Reply to Nicholas Jarvis

We would like to thank Nicholas Jarvis for his truly relevant comments on the manuscript and we are glad that he finds that this work may show an interest for the hydrological community of subsurface drainage. We agree with most of the comments and we propose an answer for each specific comment and a suggestion for correction accordingly hereafter.

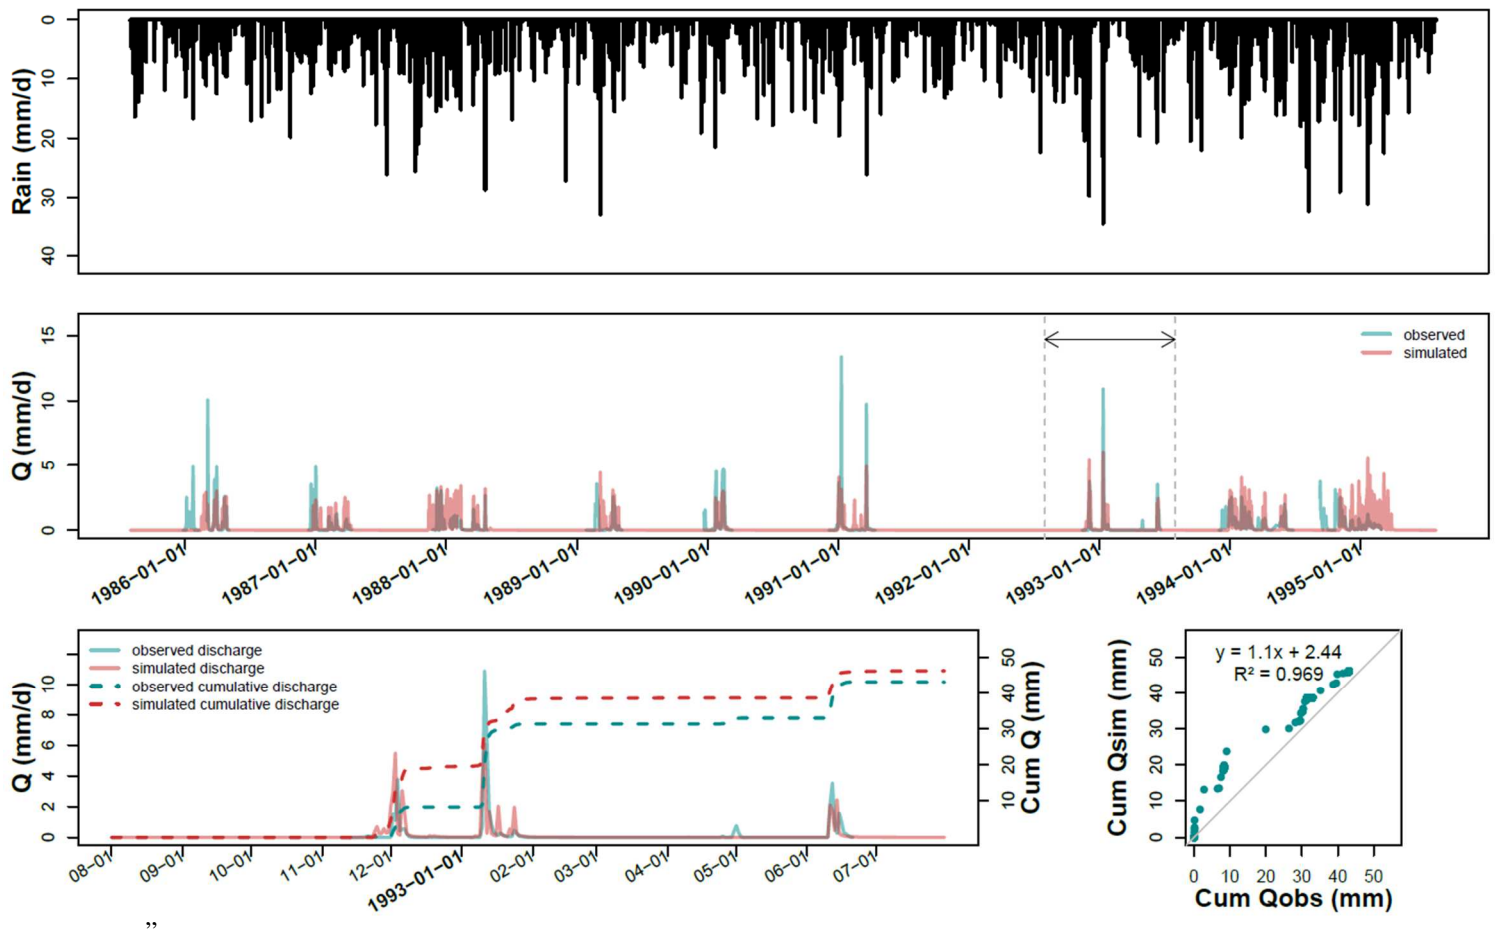
4. Lines 301-303: It would help readers to better understand the model limitations for clay soils if the authors also showed some plots of the results for the Courcival site at this point.

5. Lines 310-311: do you mean that the model gets the timing of the start of drainage in clay soils wrong by a whole month? Please clarify. It would help to show this in a figure (see point 4).

- Reply: the reviewer is right, presenting the case of Courcival, among the clayey soils, would obviously be interesting to show the reader a situation in which SIDRA-RU is not good, introducing a new figure. We propose the following correction after the line 314 in the Results part:

“Unlike at *La Jaillière*, SIDRA-RU at *Courcival* (see Fig. 5), plot lying on a swelling clayey soil, shows larger discrepancies between observed and simulated discharges on the plots. The red and blue curves do not coincide on a significant part of the chronicles. From 1985 to 1995, simulated discharges often start later than the observed ones with delays approximately ranging from 2 weeks to 2 months. The start of the drainage season is defined here when significant discharges appear. The plots on the cumulative drained discharge on 1992-93 show that the annual drained water balance diverges by +3 mm from simulations but the linear regression shows a slope equal to 1.1, which is quite high and shows that the cumulative discharges are not well simulated. These results are consistent with the fact that SIDRA-RU at *Courcival* shows an unsatisfactory KGE' value.”
